**ADDENDUM NO. 3**  
**NEWPORT TRANSFER STATION EXPANSION**  
**CARTERET COUNTY, NORTH CAROLINA**

**SUBJECT:** **ADDENDUM NO. 3.** Dated Tuesday, February 6, 2024, to Construction Documents for the Newport Transfer Station Expansion (REBID), dated December 8, 2023, and amended via Addendum No. 1 on January 19, 2024, and Addendum No. 2 on January 31, 2024.

**C-0003**

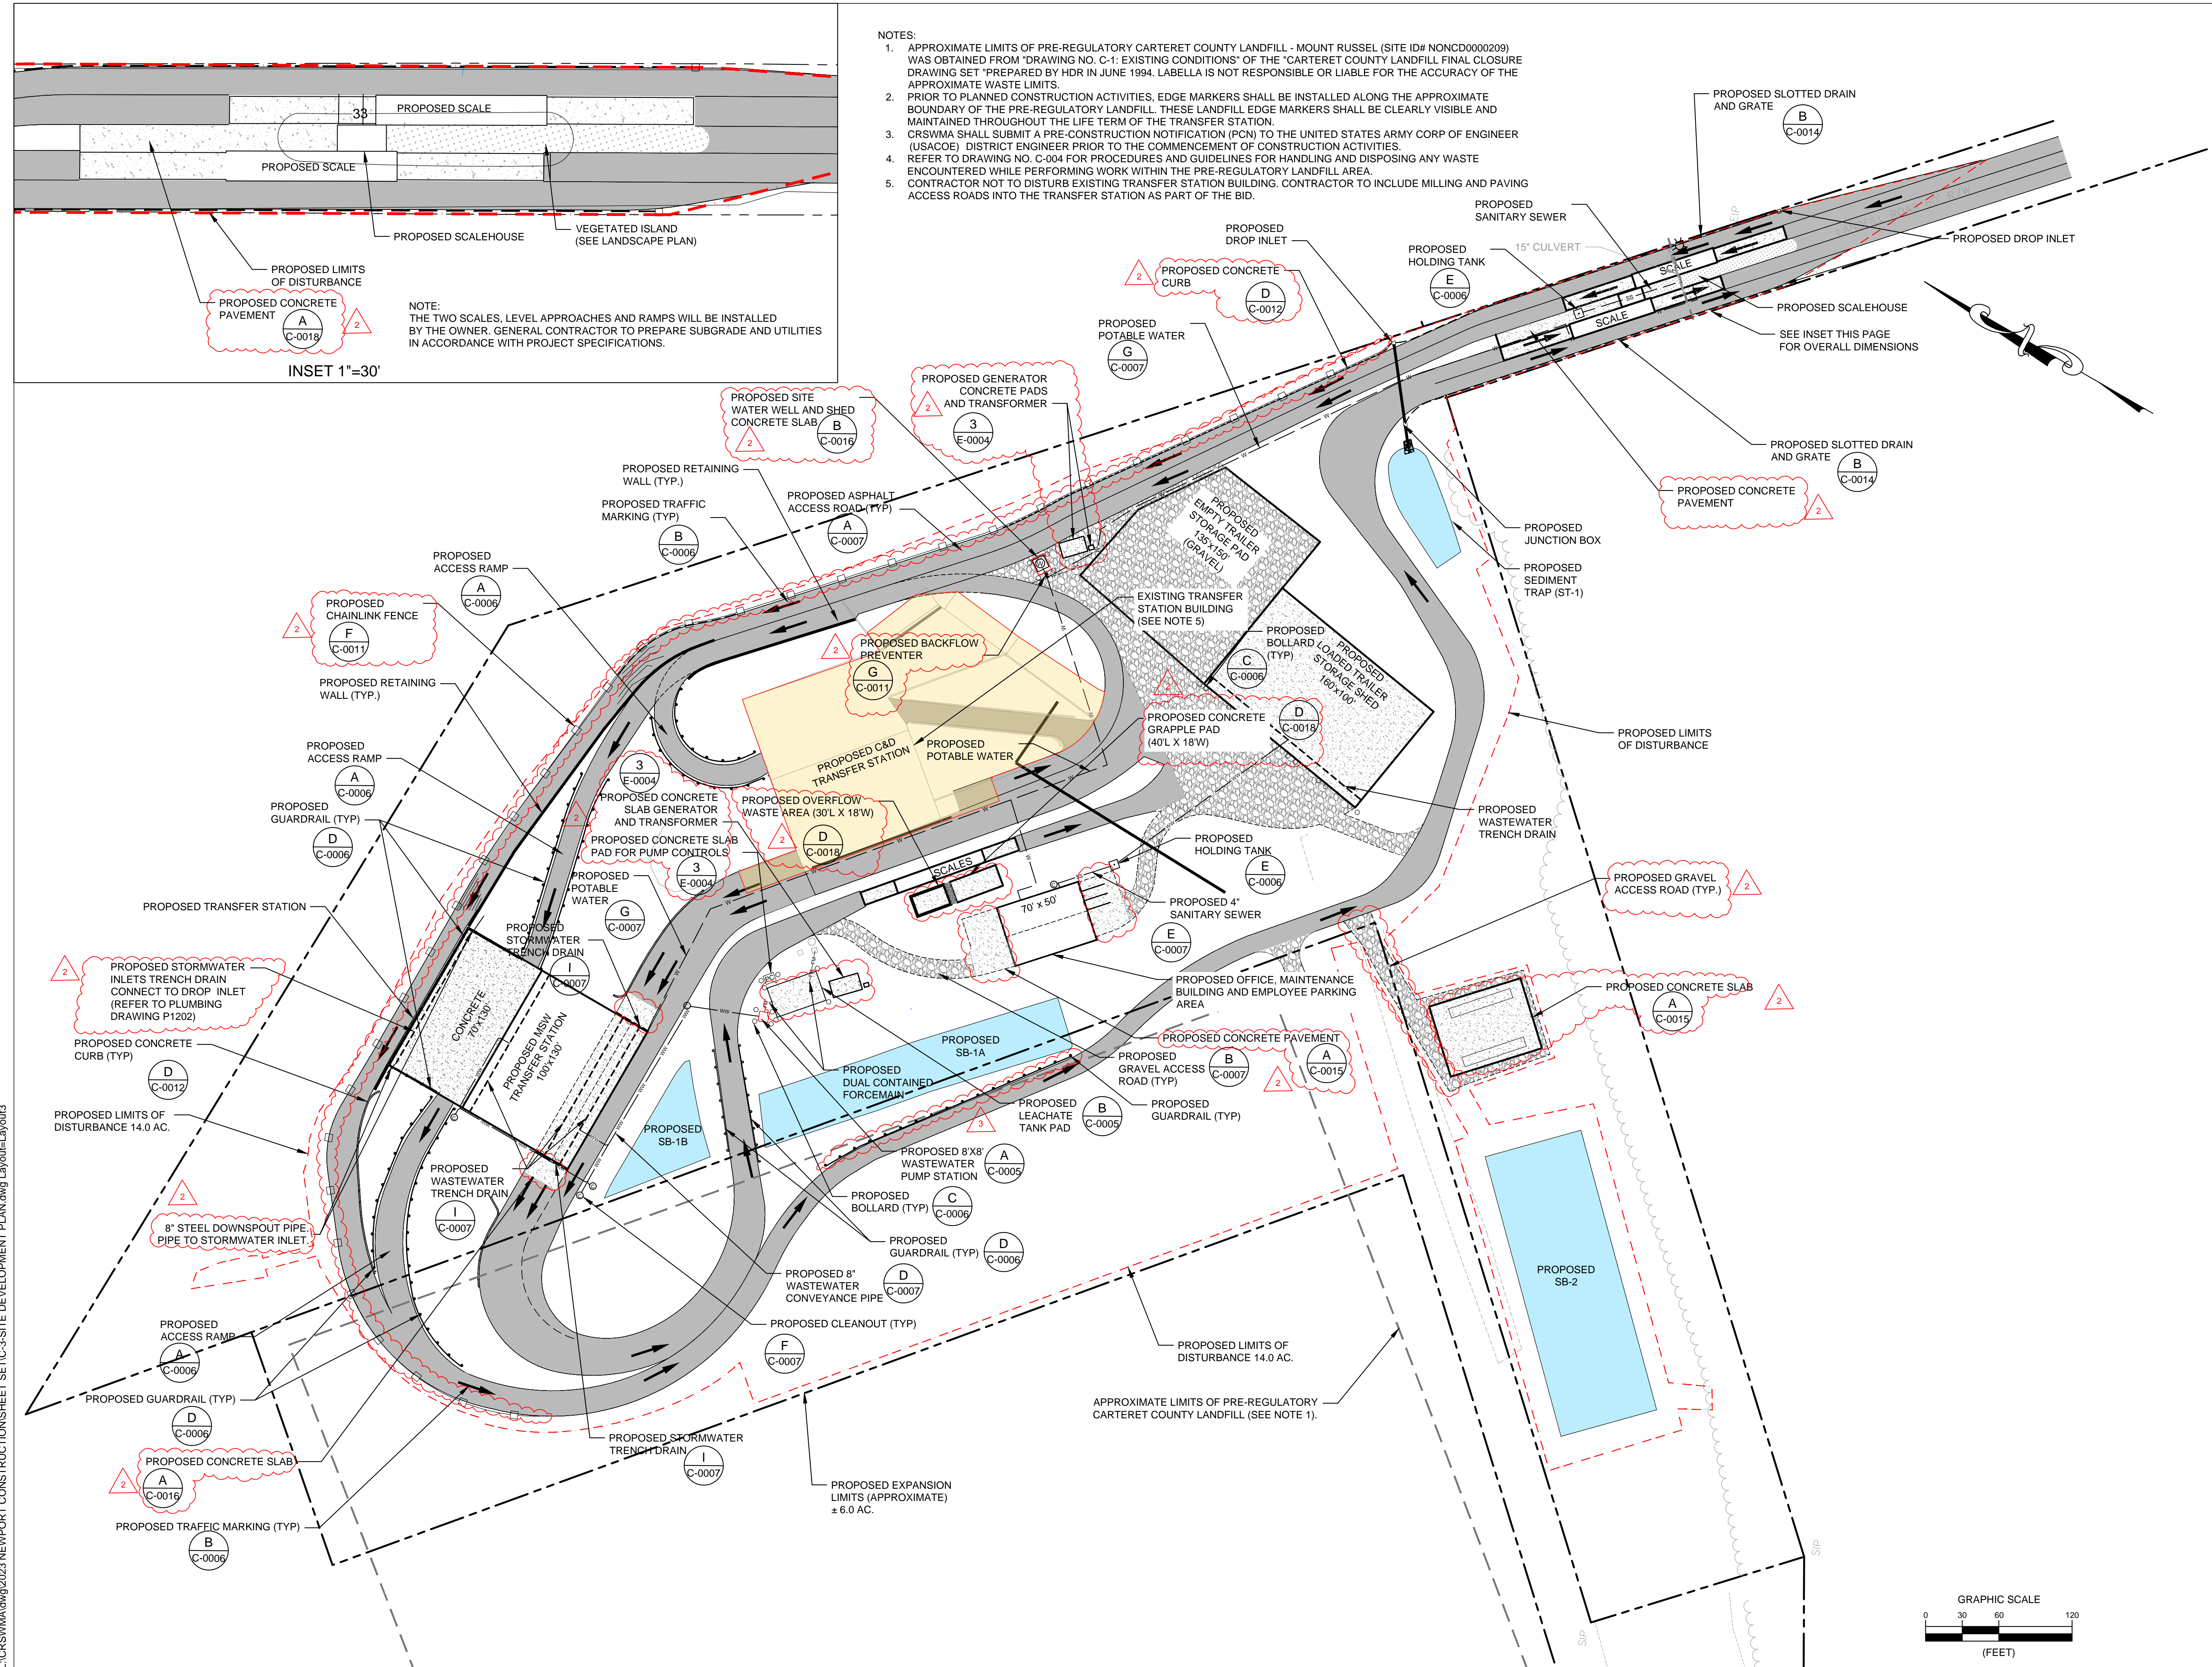
- An additional section of guardrail was added around SB-1A (i.e., SWP-1A). Refer to revised Drawing No. C-0003.
- The equalizing pipes connecting SB-1A and SB-1B were slightly realigned to accommodate grading activities associated with the basin conversion to SWP.

**C-0009**

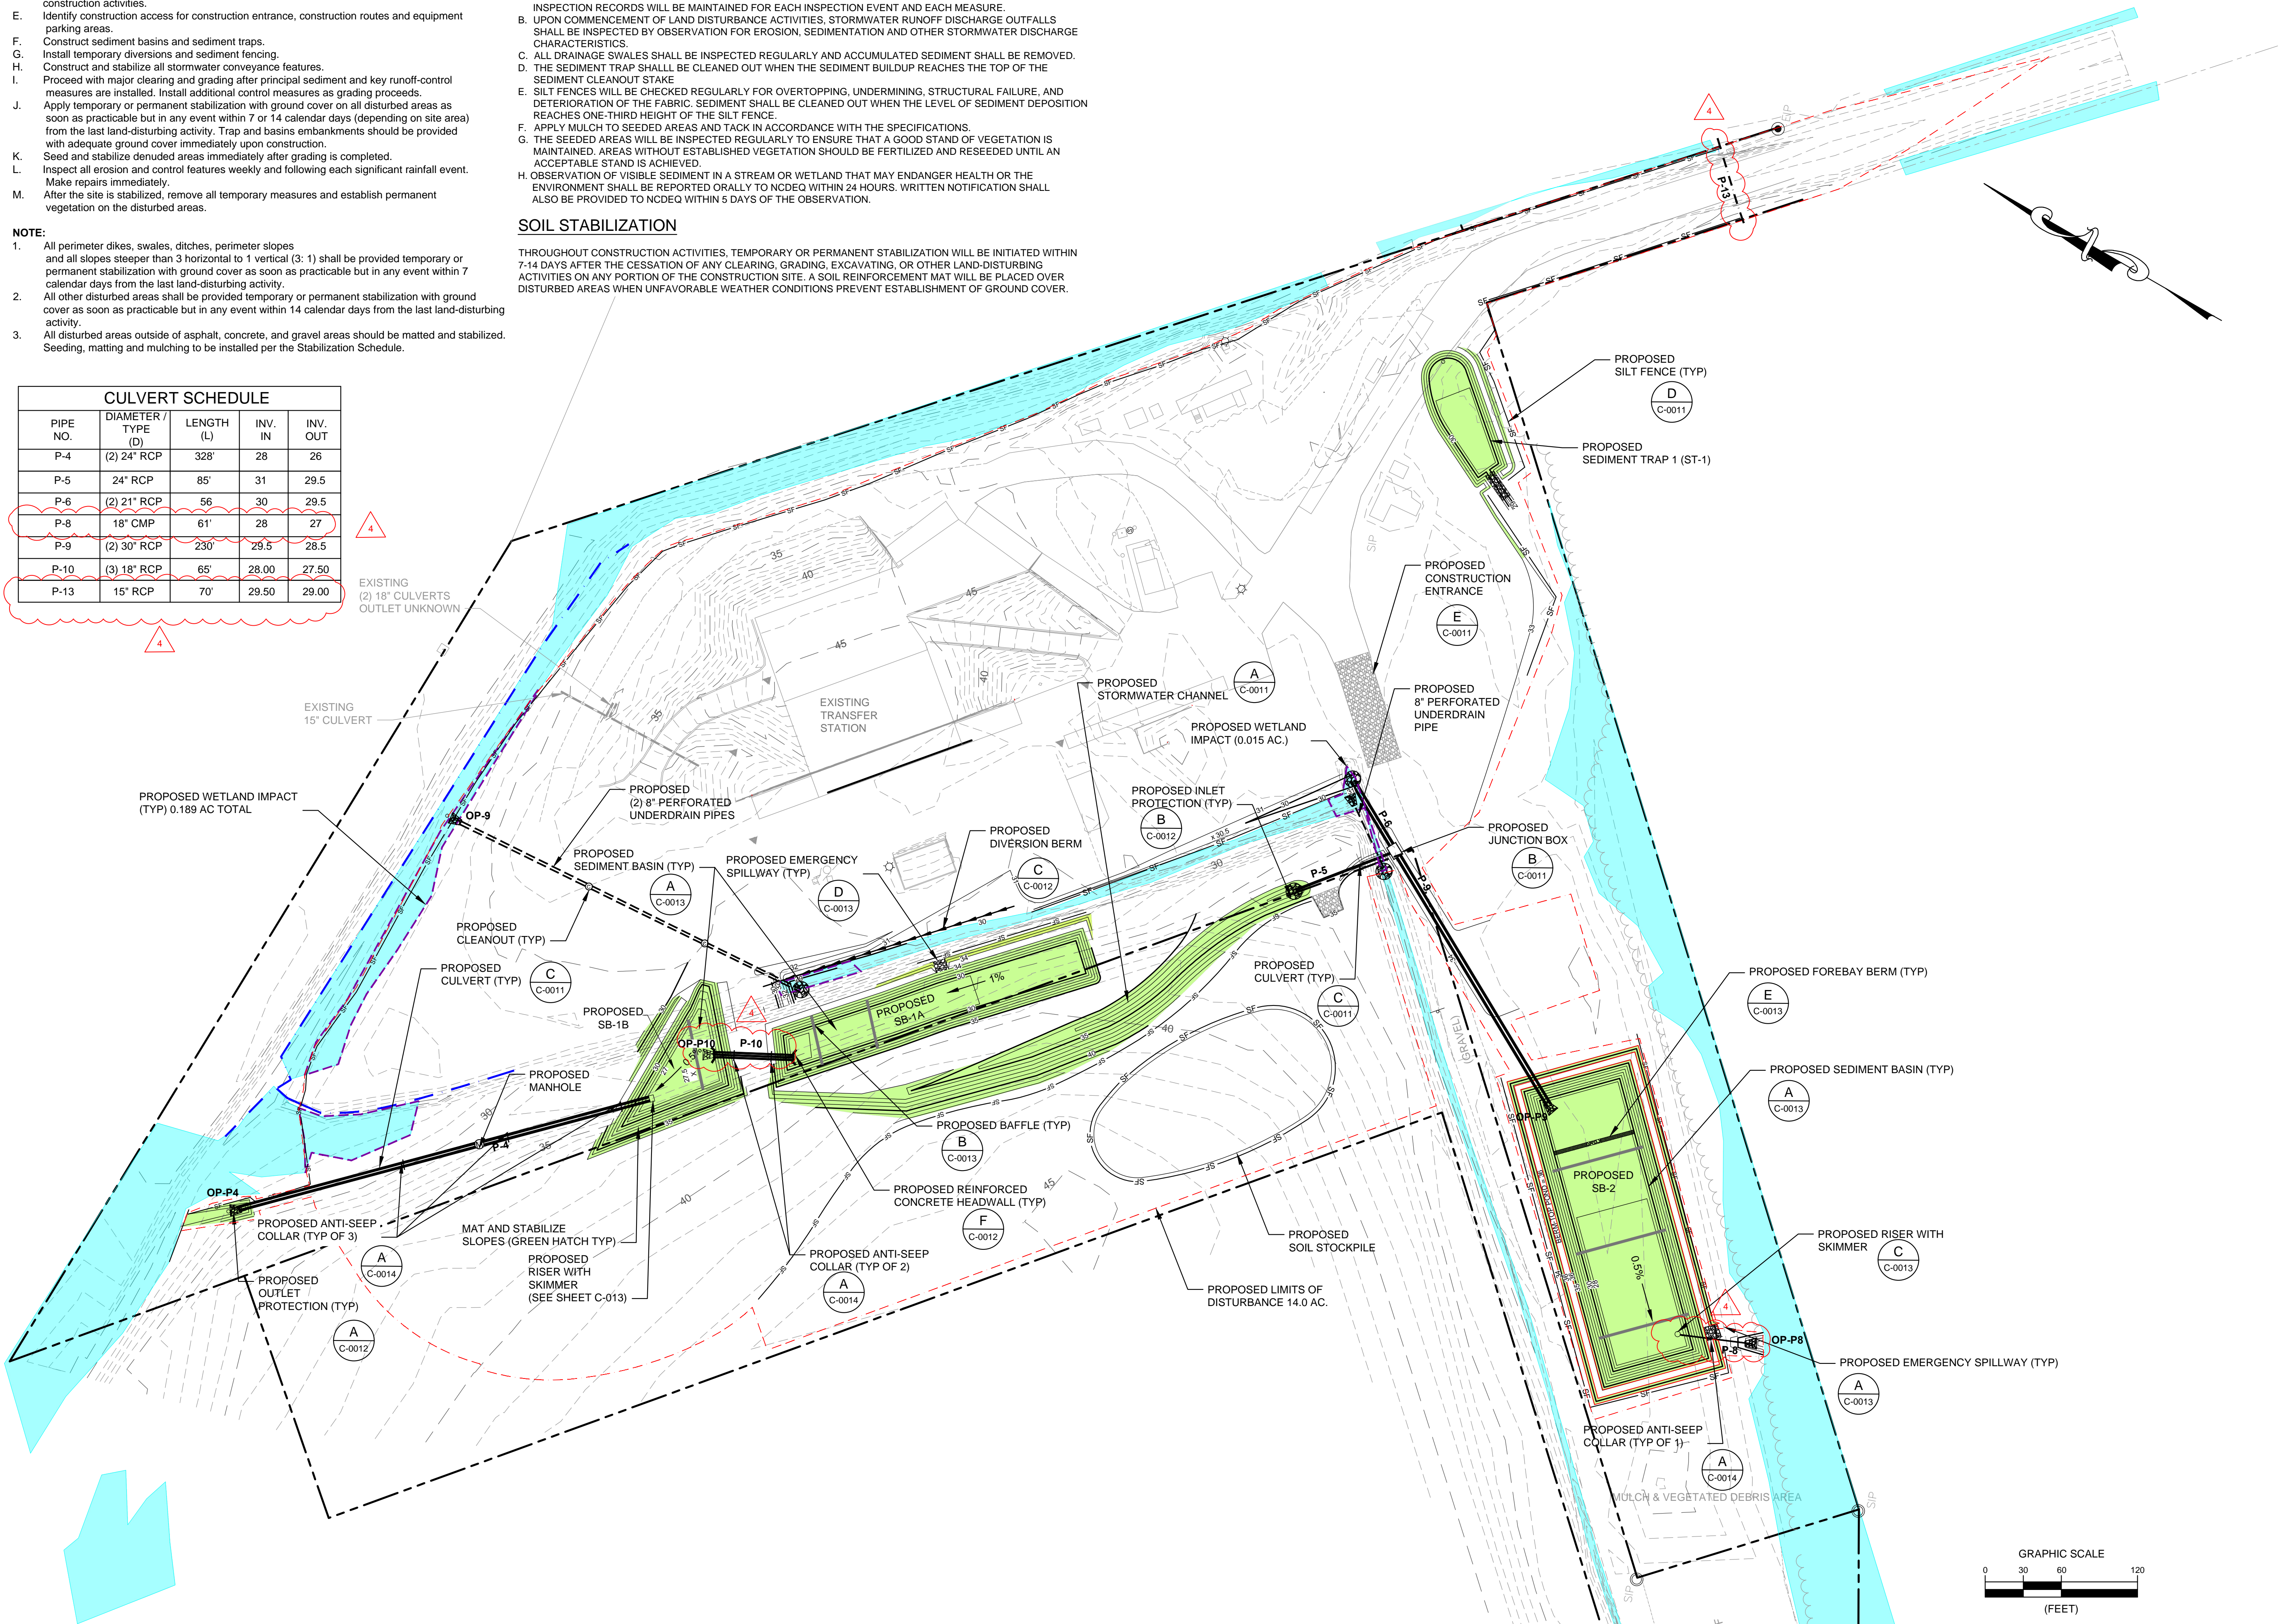
- A new pipe, P-13, was added to the site entrance to replace the existing 15" culvert. This replacement pipe was added to maintain existing site hydrology and is shown on revised Drawing Nos. C-0009 and C-0010.

**C-0010**

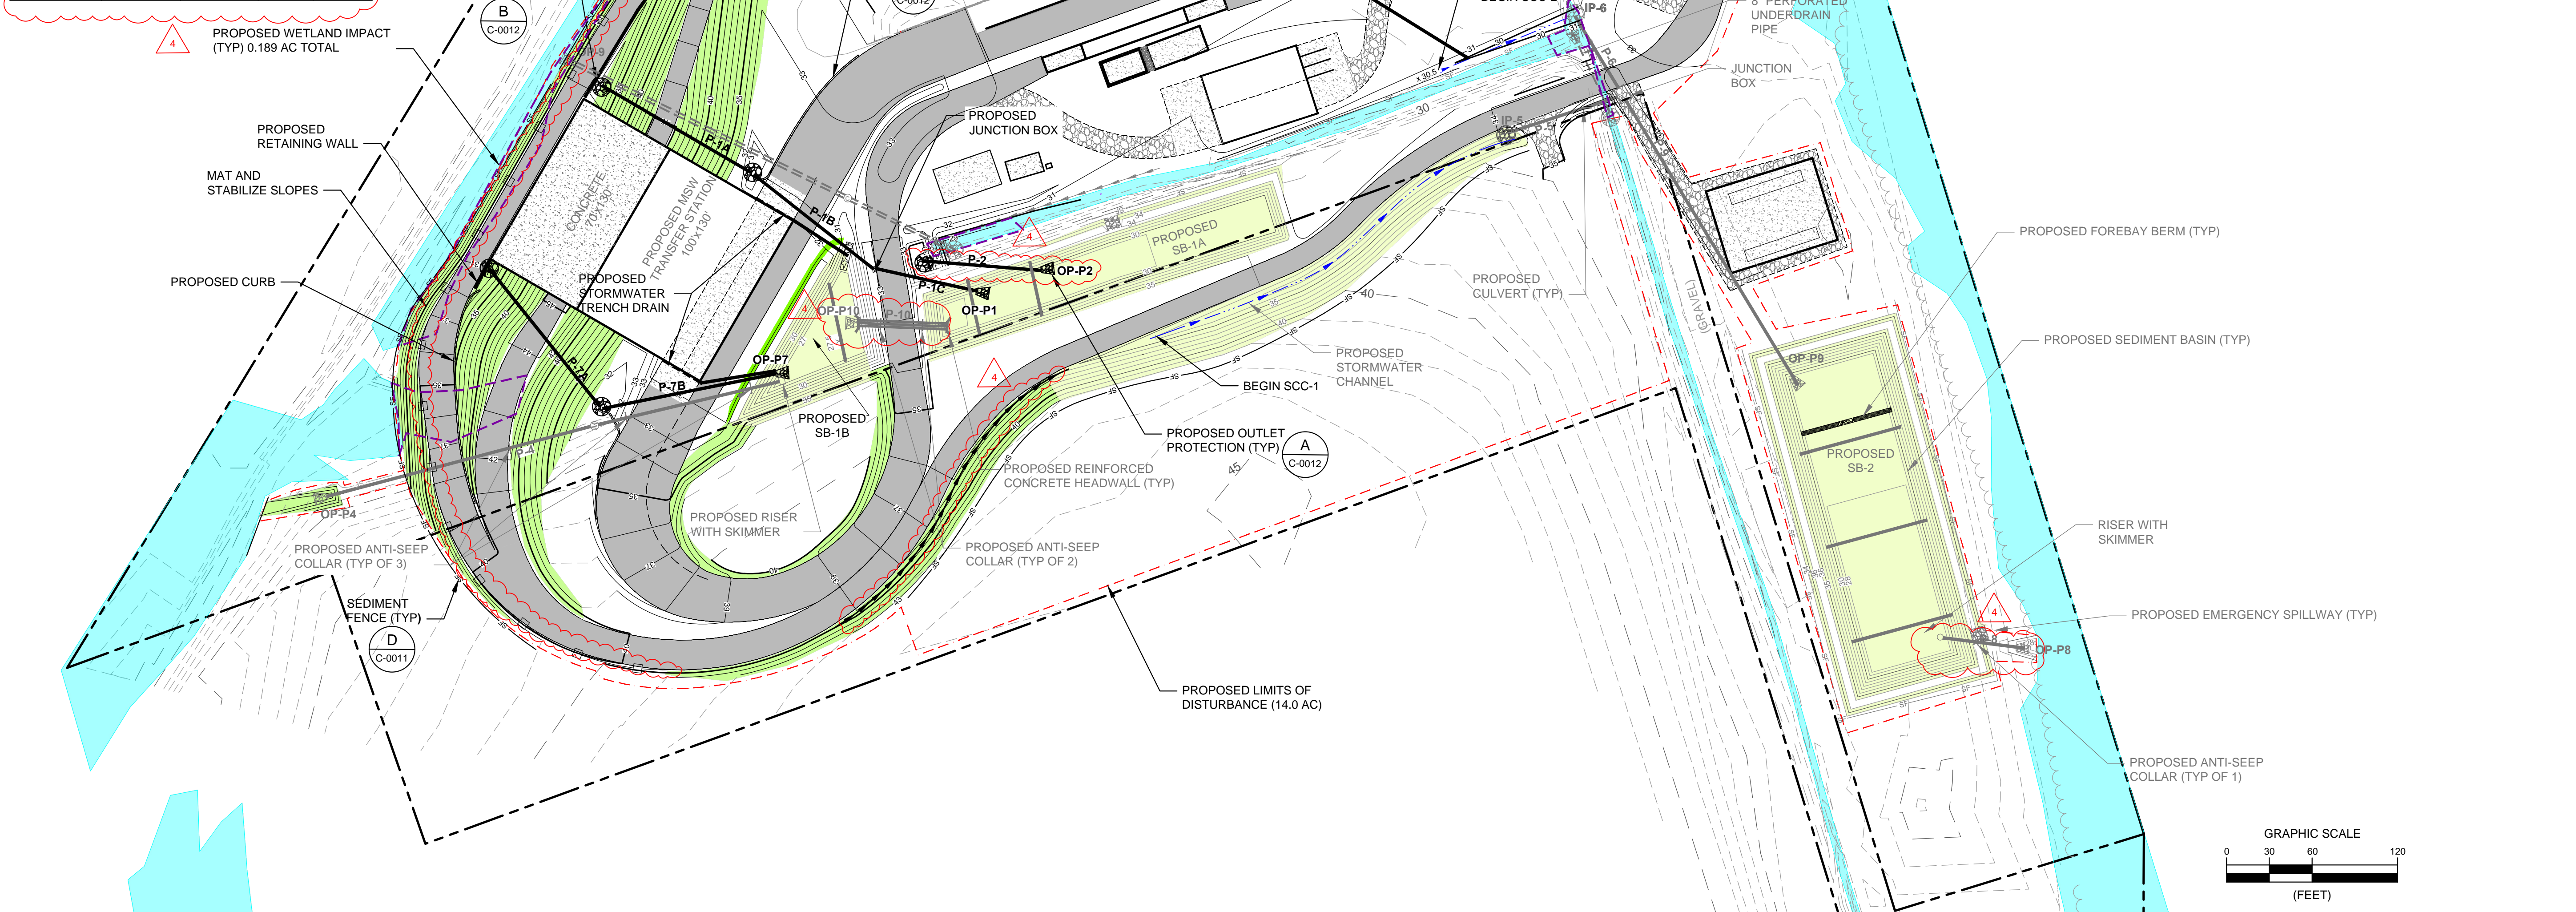
- A diversion berm, conveying water from the western road embankment to SCC-1, was added to Drawing No. C-0010.
- A new pipe, P-2R, was added. Refer to revised Drawing No. C-0010 and newly added Drawing No. C-0010A.
